MIL-F-16377/14A(SH)
AMENDMENT 1
2 August 1996

MILITARY SPECIFICATION SHEET

FIXTURES, LIGHTING; FLUORESCENT, GENERAL LIGHTING 8 WATTS, 120 VOLTS, 60 HERTZ, WATERTIGHT SYMBOLS 79.1, 79.2, 80.1 AND 80.2

FIGURE 9. Wiring diagram.

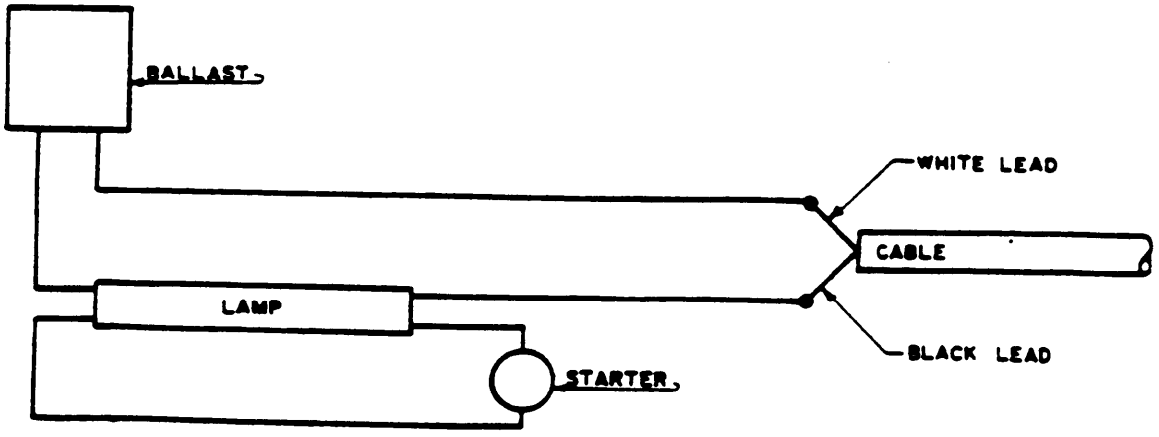
Page 6a/6b.
